L-2018-223
10 CFR 54.17

December 14, 2018

Re: Florida Power & Light Company
Turkey Point Units 3 and 4
Docket Nos. 50-250 and 50-251
Turkey Point Units 3 and 4 Subsequent License Renewal Application Safety
Review - November 15, 2018 Public Meeting Action Item Responses

Revise Figures 4.5-7, 8, 9, 10 as follows:

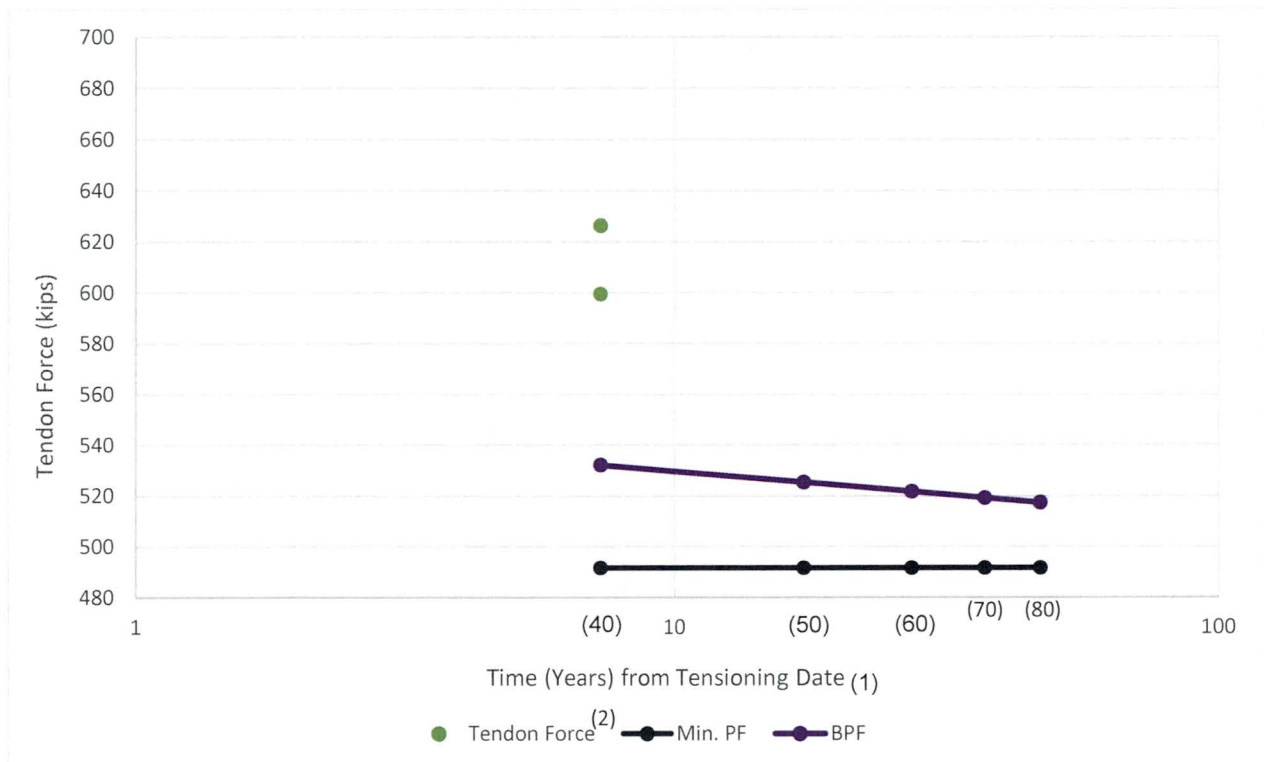
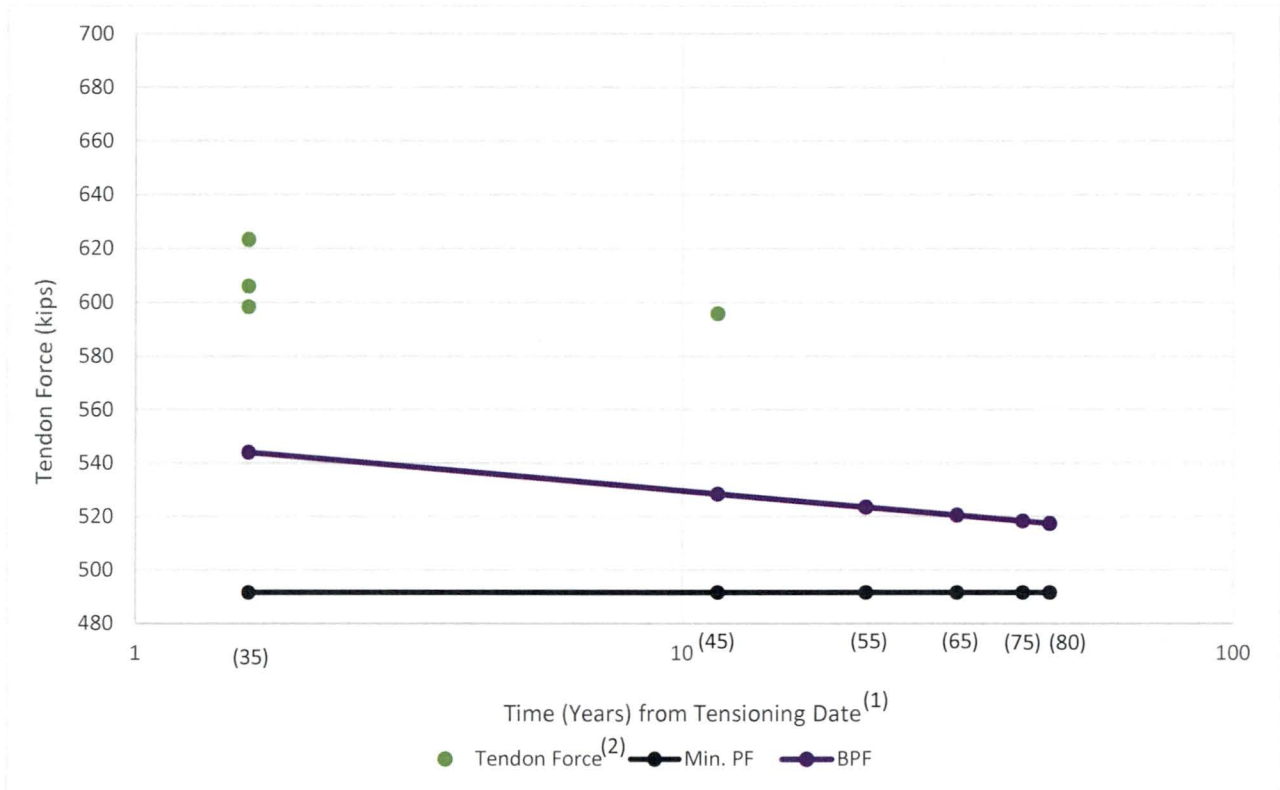
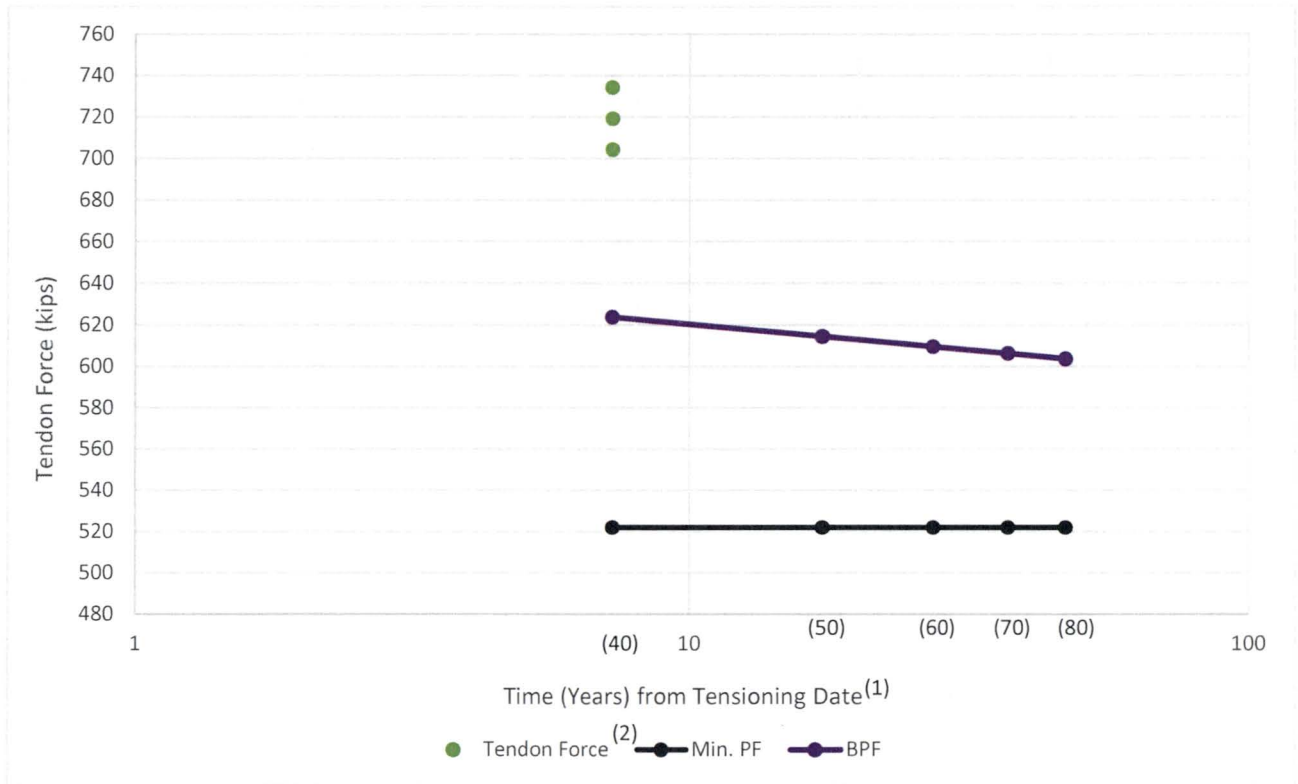
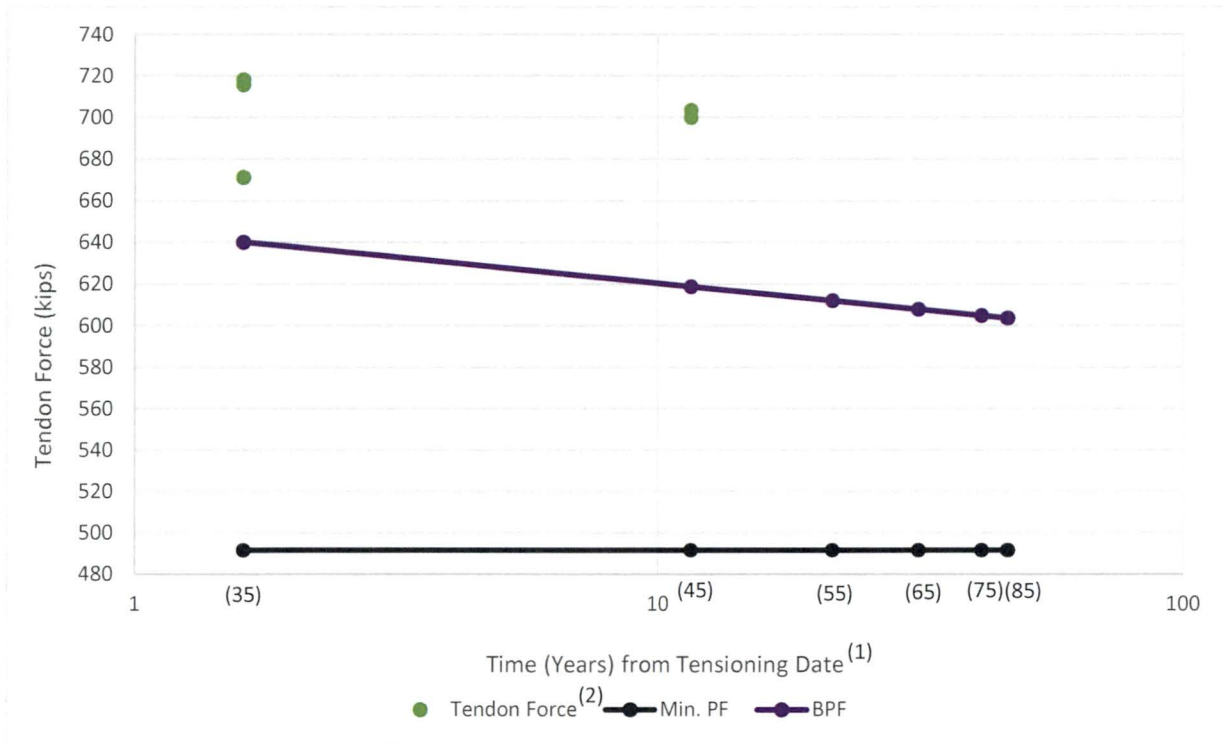
In Figure 4.5-8, one result is listed for the Unit 4 hoop tendon 45th year (vs. the sample size of two) since one of the RVCH tendons (tendon 15H35) was surveyed as an alternate for the planned inspection RVCH tendon (tendon 15H32) that was determined to be inaccessible. The data for the alternate RVCH tendon (tendon 15H35) was not displayed in the TLAA Figure 4.5-8 since only average lift-off force for the tendon could be reported. The tendon lift-off data analyzed and presented in the TLAA for License Renewal (surveillance years 1-25) and the 30th and 35th years' surveillance reports is presented as normalized lift-off forces. The data in the 40th and 45th years' surveillance reports is presented as average lift-off forces. Instead of applying the Normalization Factor to the as-found lift-off force, the 40th and 45th surveillance report methodology applies the Normalization Factor to the Baseline Predicted Force. The 45th years' tendon selection and predicted forces report is used to convert the average lift-off force data to normalized lift-off force data by back-calculating the Normalization Factor from the Baseline Predicted Force. Since tendon 15H35 was not a planned inspection tendon, the predicted force (PF) and baseline predicted force (BPF) were not calculated in the tendon selection and predicted forces report. Therefore, the Normalization Factor could not be determined. The average lift-off force is greater than the PF and BPF; therefore, the tendon force is acceptable.

- The Turkey Point Unit 3 and Unit 4 RVCH Replacement Projects required a containment access opening consisting of the removal and later replacement of a section of the containment structures. The Unit 3 and Unit 4 tendons affected by the RVCH modification are considered as augmented scope tendons and are analyzed separately from the Unit 3 and Unit 4 tendons for SLR. The tendon loss of prestress calculation was updated to separate the augmented scope tendons from the original scope tendons which eliminated the considerable tendon lift-off force variation.
